Audit of the Remediation of the former Fruitgrowers Chemical Company Site, Mapua

∴ Prepared for
Ministry for the Environment

∴ June 2009

PATTLE DELAMORE PARTNERS LTD

Figure 3 : FCC WEST and FCC Landfill- Cell and Subgrade Layout

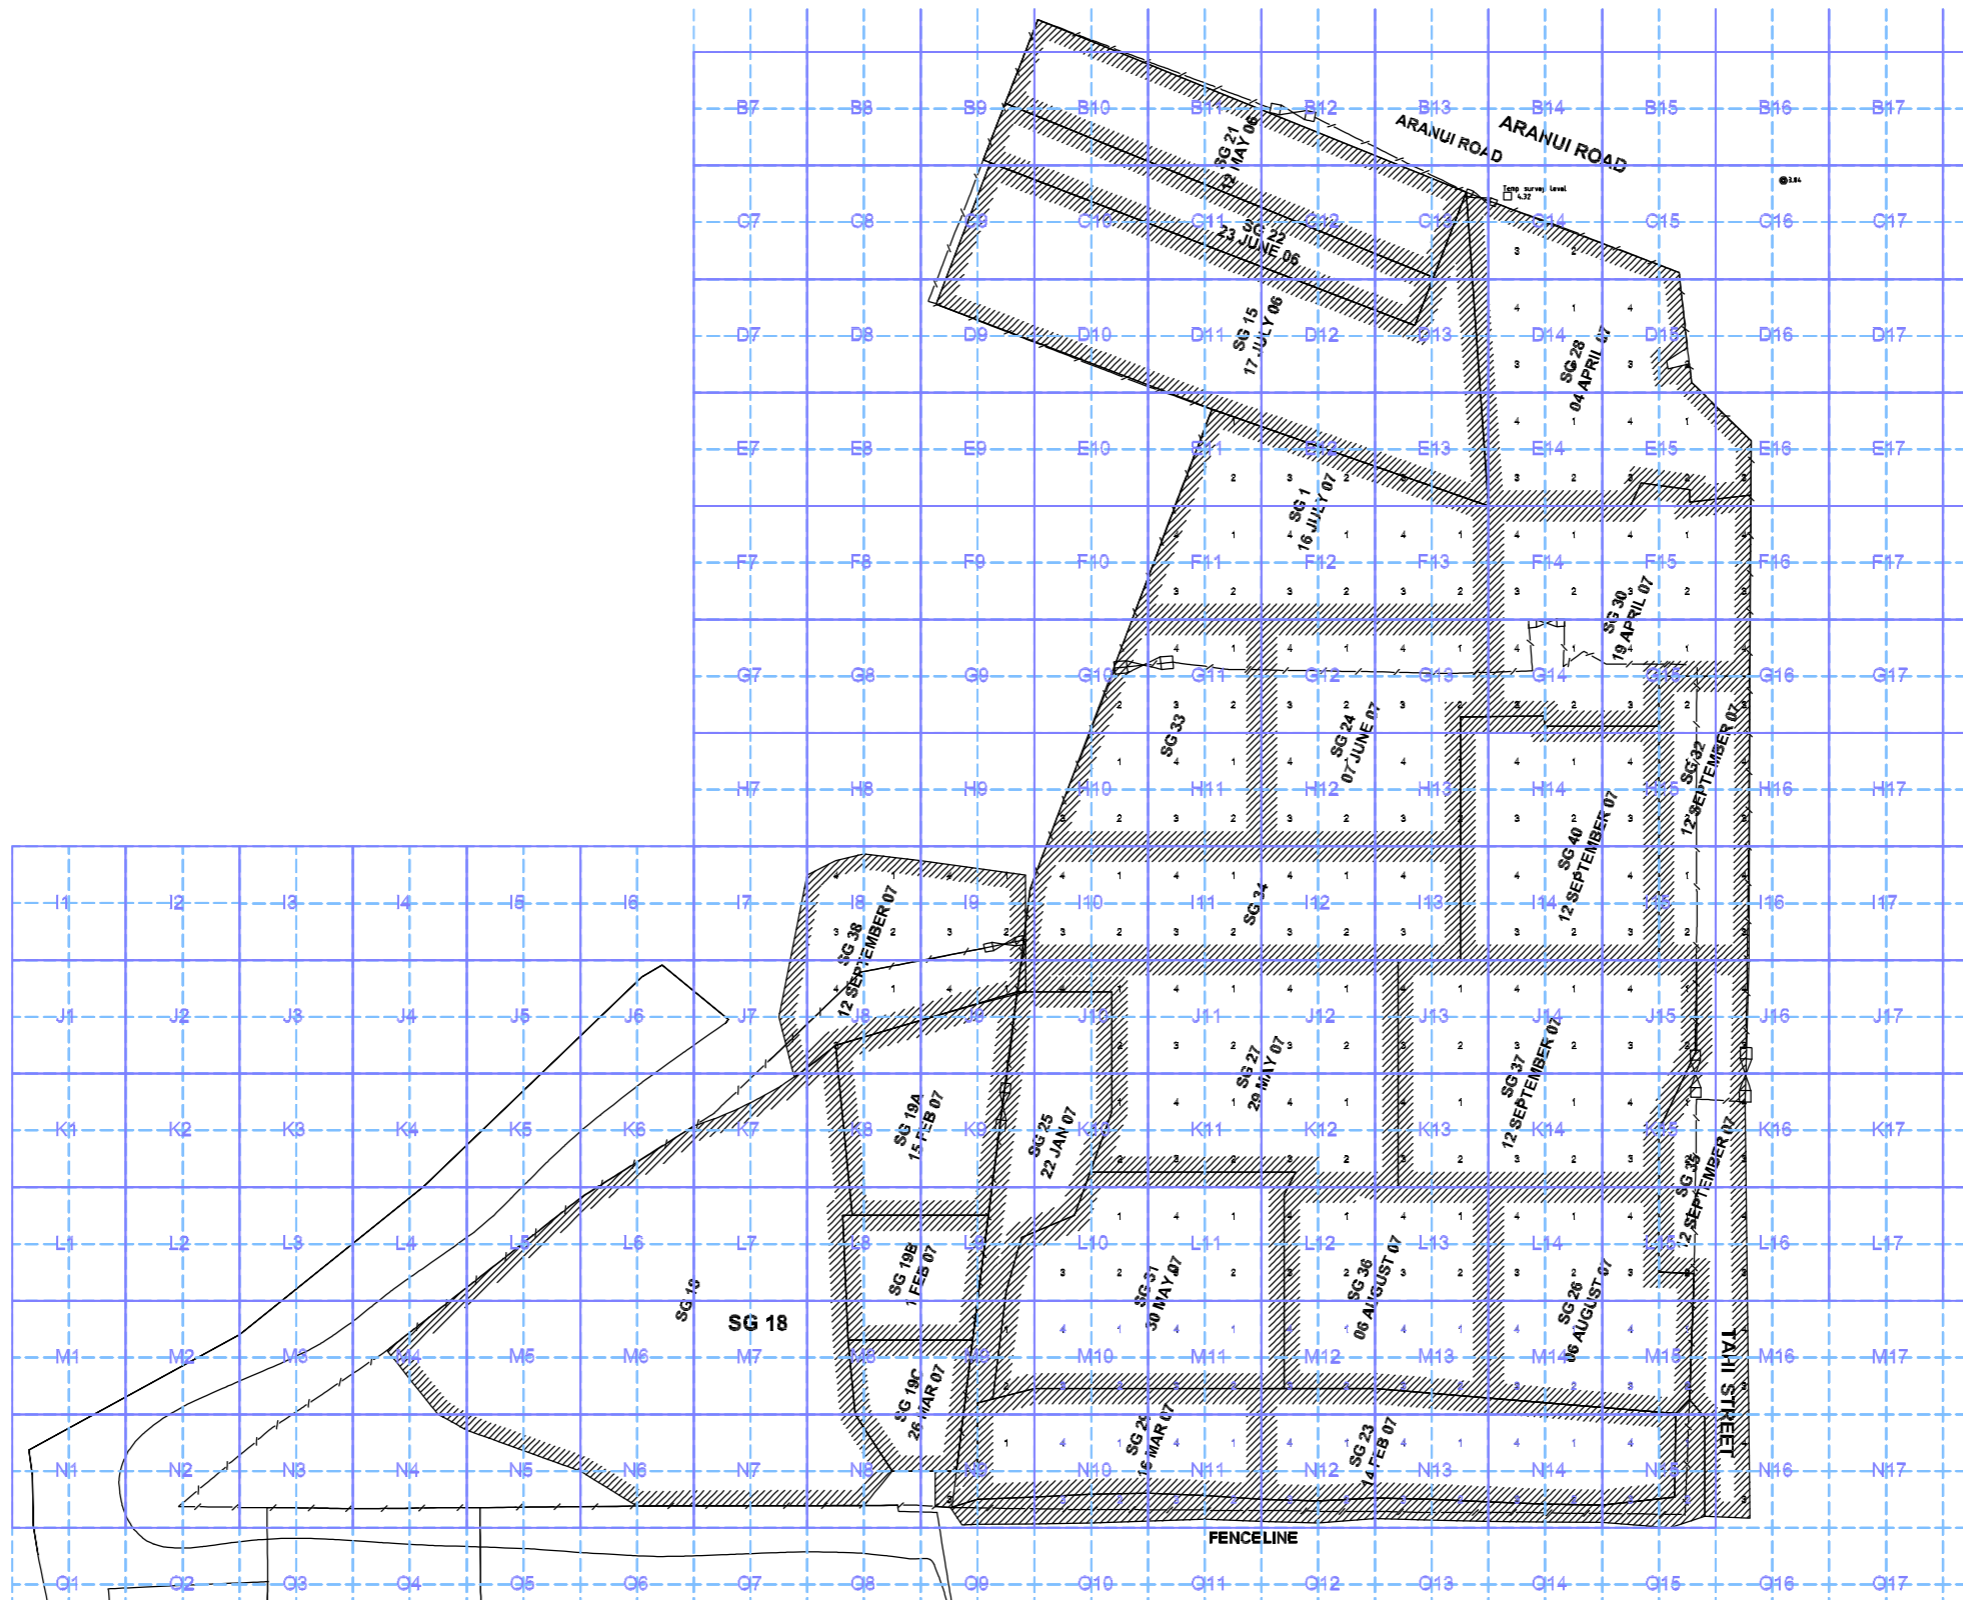
The landfill covered an area of approximately 6000 m². Subgrade SG 18 formed the majority of the excavation in FCC Landfill (Figure 3). The north-west, south-west and south edges of SG 18 were approximately coincident with the extent of the waste i.e. the excavation was extended to 'clean soil'.

- Treated fines material was placed at depth in subgrades SG19A, SG19B and SH19C, while mixed treated fines material was placed in these and subgrade SG18 up to 0.5 m from the surface. There is an unknown potential for generation of ammonia gas. Currently the grass cover appears healthy. The potential for generation of ammonia in this area is not expected to create a particular human health risk for day-to-day use as open space. No buildings are planned for this area and excavation is expected to be infrequent. Testing for ammonia in soil gas is not required in this area, but confined space precautions should be taken if any excavation does take place in the area.

- The treated fines also have elevated concentrations of copper, which could cause phytotoxic effects for some deeper-rooted shrubs and trees. Shallow-rooted plants within the surface 0.5 m of residential / topsoil material should not be affected. The issue is readily managed by replacement of soil around deeper rooted plants where treated fines or mixed treated fines were buried close to the surface.

Figure 4 : EAST MARINE EXCAVATION - Approximate Sample Locations

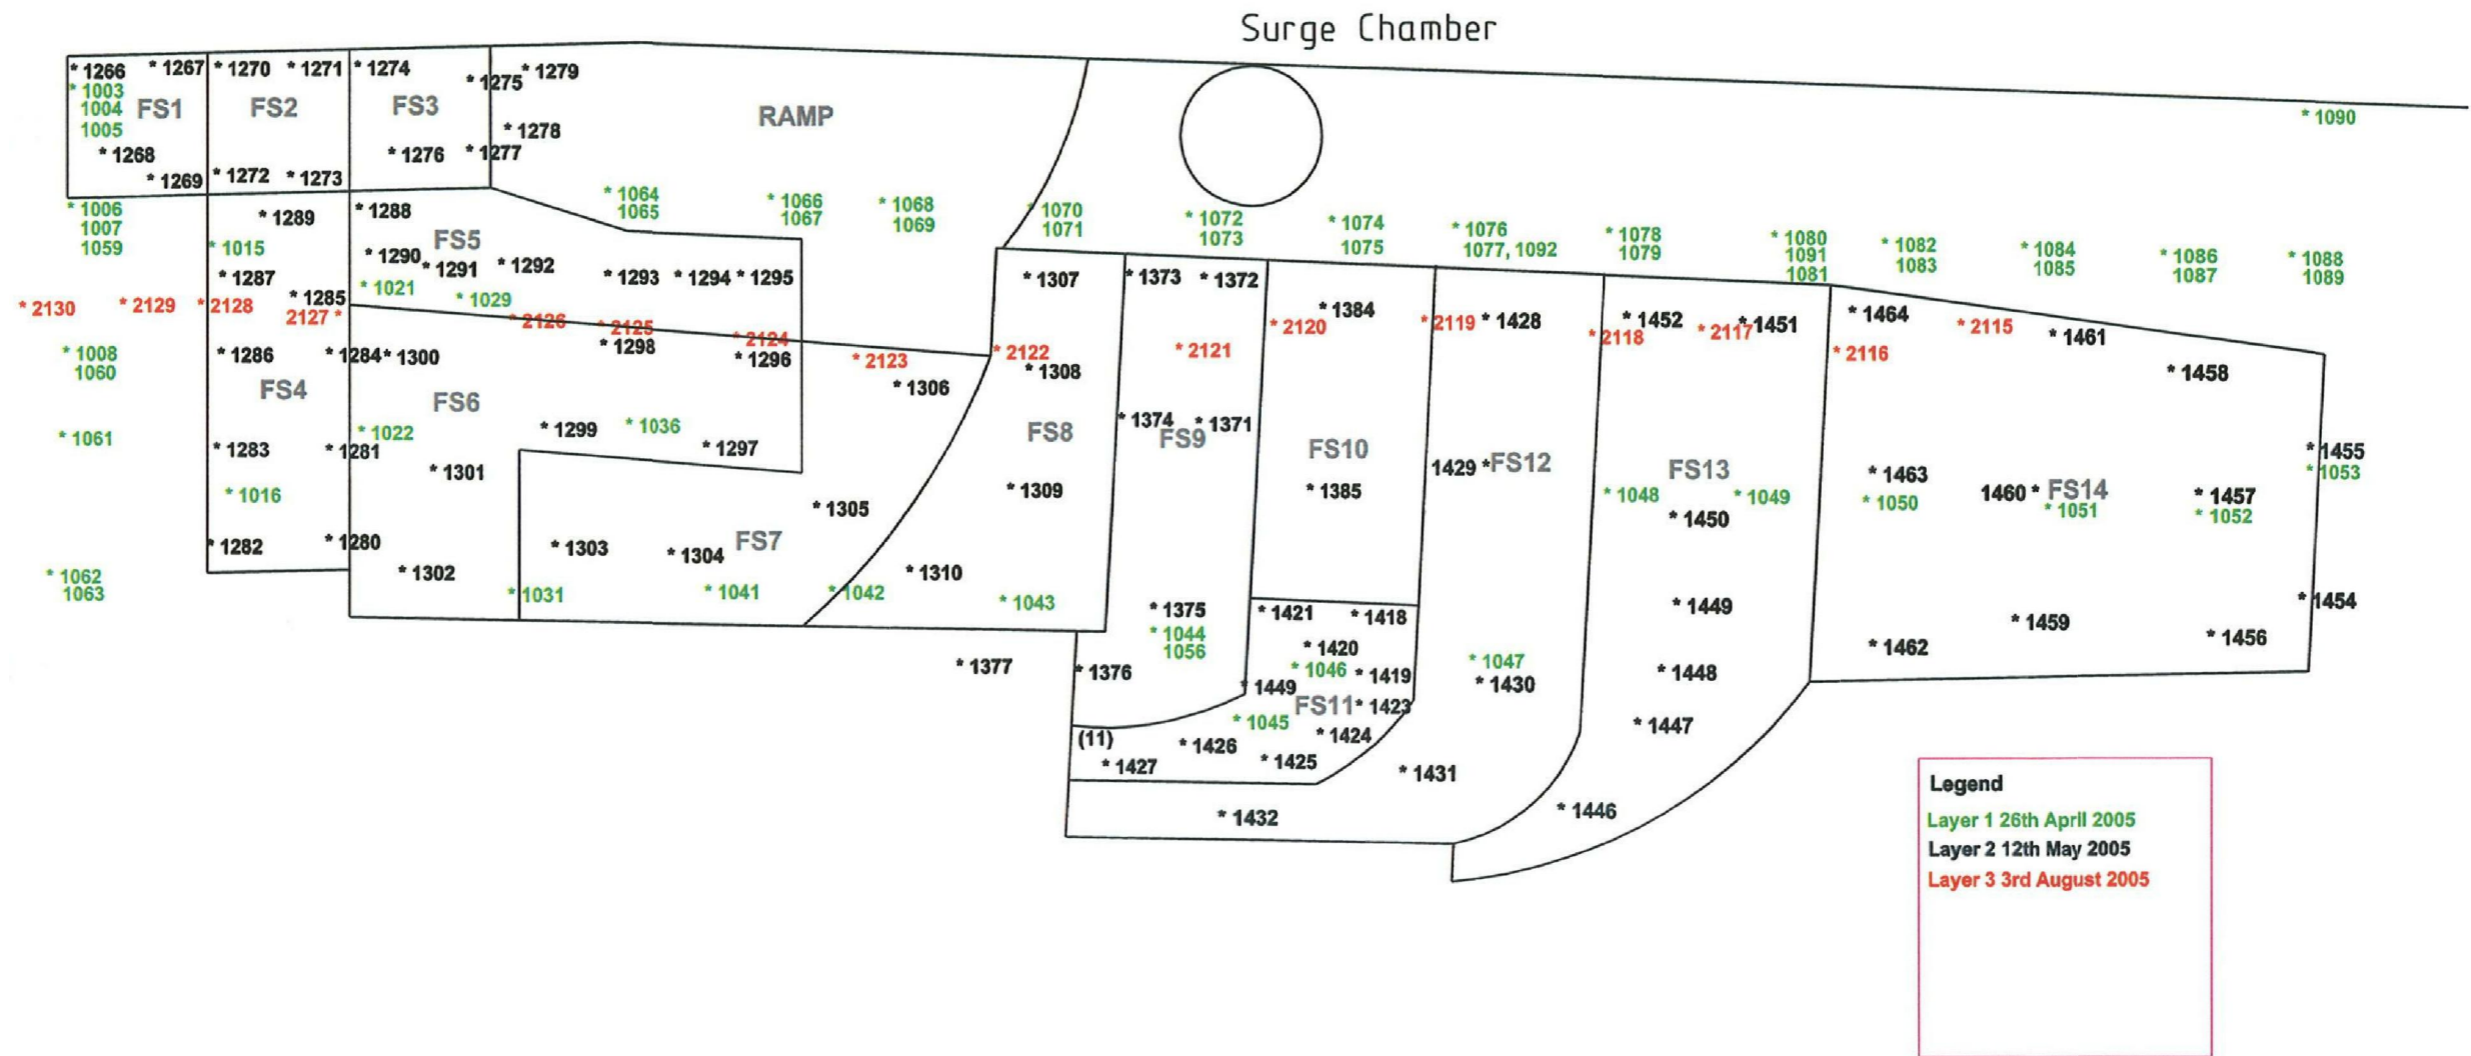
In April 2005, a series of sediment samples were collected to attempt to characterise the contamination prior to remediation. The sample locations are shown in green on Figure 4. Samples were collected variously from 0.15, 0.5 and 1.0 m depths and analysed for DDX and ADL. The results indicated elevated concentrations of these contaminants, with only three of the 57 samples analysed for DDX returning concentrations below the marine SAC of 0.01 mg/kg. The maximum DDX concentration of approximately 8.5 mg/kg was detected at 0.5 m depth close to the toe of the former bund. There were approximately 19 samples with DDX concentrations above 1 mg/kg, with most of these located along the toe of the former bund. Concentrations above 1 mg/kg were detected at 0.5 m depth at six locations, with no analytical data from below that depth to show the vertical extent of the contamination.

The removal of marine sediment occurred in early May 2005. The excavation was undertaken in a series of individual cells (FS1 – FS14 on Figure 4), extending into the channel by up to about 30 m from the toe of the bund. As required by the consent, each cell was excavated and backfilled within one tidal cycle i.e. above water. The depth of excavation ranged from approximately 0.25 m to 1.0 m below the original surface, with an average of about 0.5 m. This was greater than originally planned. The excavations were backfilled with an imported coarse river sand/gravel (see Section 6.3.6 for further detail).

From the information obtained, it is not clear whether the area represented by the pre-excavation samples 1072 – 1089 has been remediated (Figure 4). It would appear that these areas were not included in the marine sediment remediation works i.e. they are not within cells FS1 – FS14. However, it is likely that at least the central part of this strip of beach was remediated during the works to remove the surge chamber (subgrades SG10 and SG13 on Figure 2). In addition, the works to construct the sea wall are likely to have overlapped these sample locations to some extent. This is difficult to confirm as the position of the samples cannot be accurately determined from the location plan.

Validation samples were collected from the base of each excavation immediately prior to backfilling. These samples are presented in black on Figure 4 and labelled as 'Layer 2 12th May 2005' on the legend. All 86 of these samples were analysed for the full OCP suite, including DDX and ADL. A further 31 samples were analysed for TPH, OPP, ONP and VOCs. Six samples were analysed for the 10% suite which includes heavy metals,

A subsequent set of 16 samples was collected about three months after the remediation works. These samples were collected from approximately 0.3 m depth in a line along the beach, as indicated by the red samples on Figure 4, and analysed for the full OCP suite. It is not stated what the target stratum was for this sampling, however, the sample depth would tend to imply that the samples were collected from within the remediation backfill material.

Figure 5 : WEST MARINE EXCAVATION - Approximate Extent

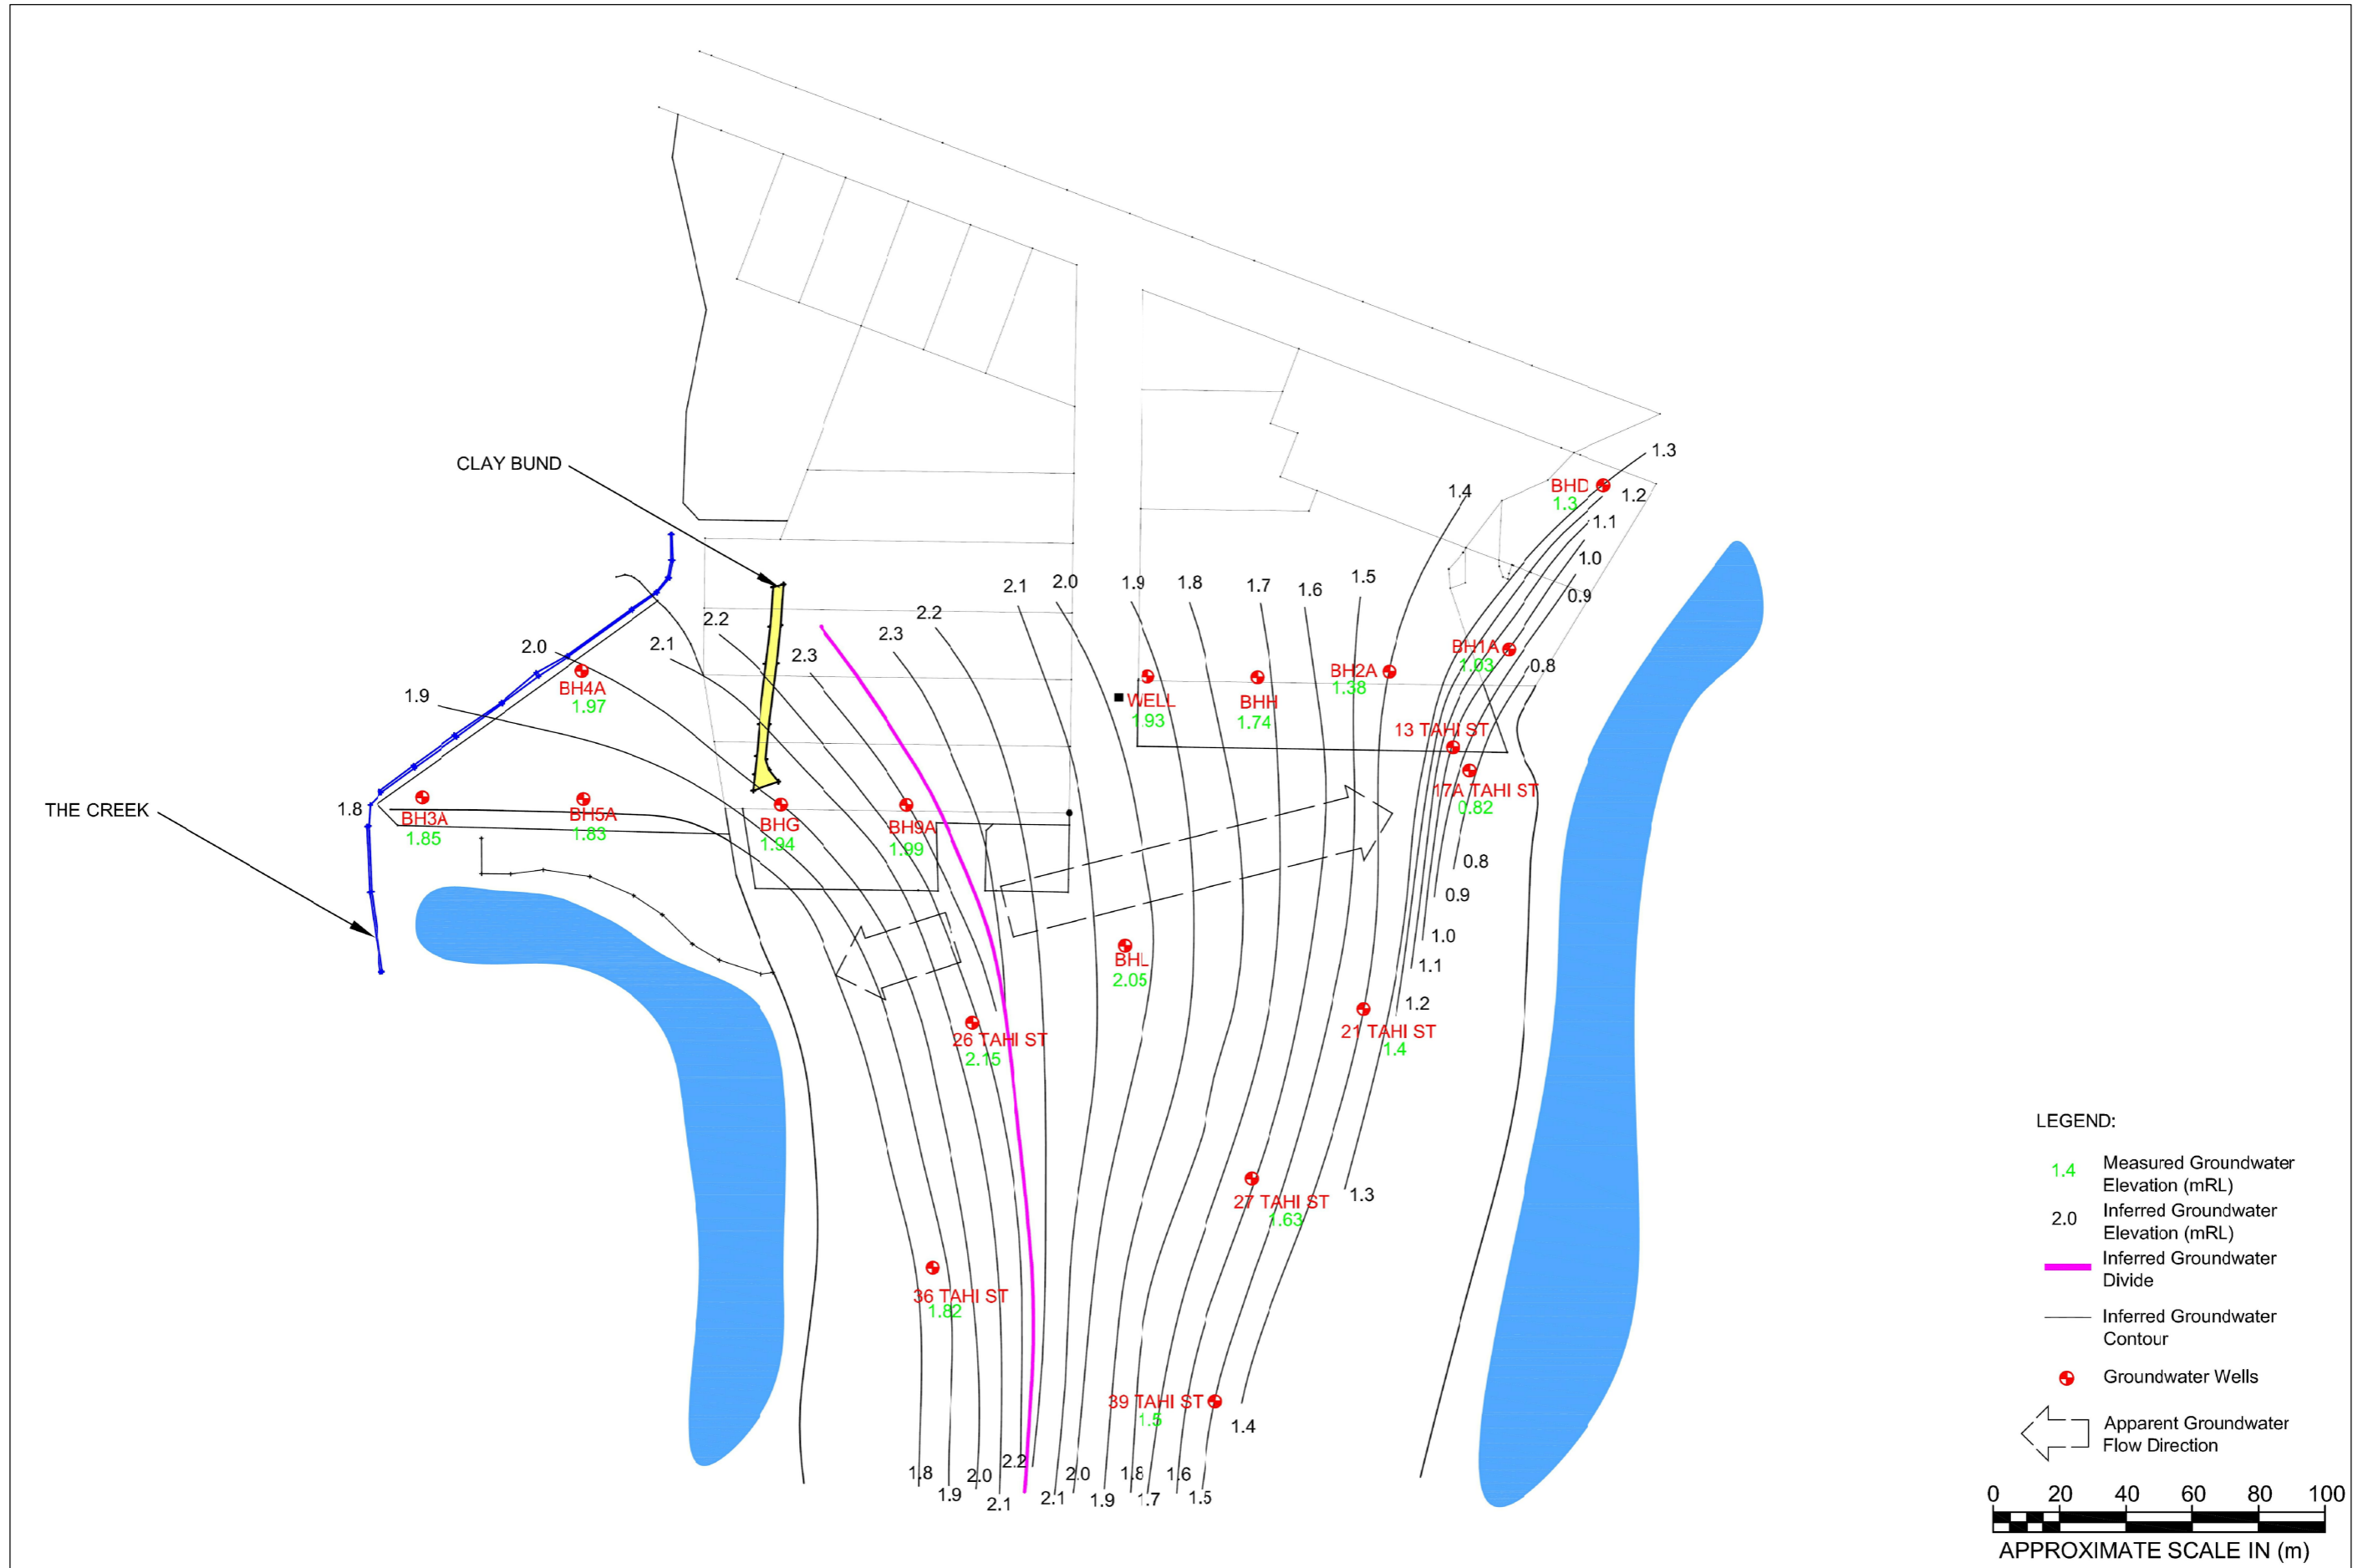
In September and October of 2007, the surface 100 mm layer of sediment was removed across the approximate area of the original foreshore remediation excavation as a follow-up to finding excessive concentrations in sediment samples in May and July 2007 (TDC, 2007a, 2008a). This excavation created a shallow pond on the eastern half of the foreshore. Similarly, approximately 100 mm of sediment was removed from the stream bed in cells O1, N1 and M2 (see Figure 5).
